Product Change Notification

Change Notification #: 116586 - 00
Change Title: Intel® Server System R1304WTTGSR, PCN 116586-00, Product Design, Rear panel and rear brackets new design, Factory Firmware update, Grommet color change.
Date of Publication: November 12, 2018

1. Change the design of the left rear bracket

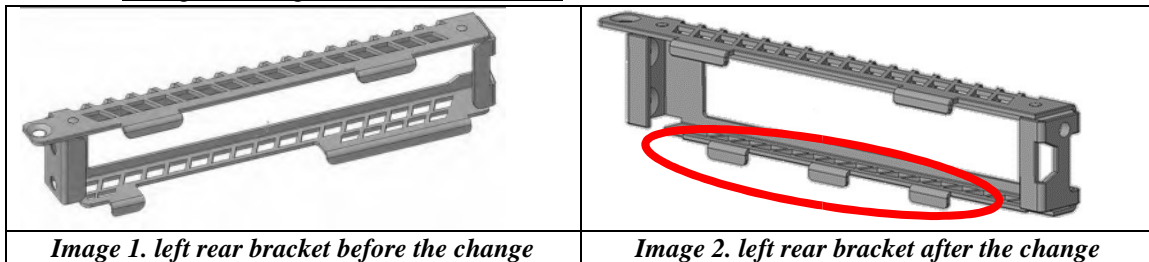
Change 1: To improve the connection of Small Form-factor Pluggable transceiver (SFP+) cables on the rear panel and the miniSAS connection. This change requires to change the MM# from 943891 to 977052.

Image 7. Fan holding Grommet previous changes (color is blue)

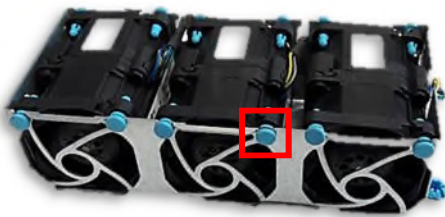
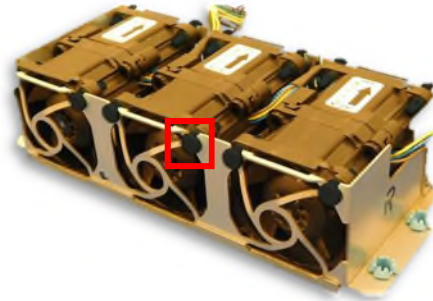
Change 2: Intel® is changing the color on the Fan holding Grommet J76819 (See below images).

Image 8. Fan holding Grommet with the changes (color is black)
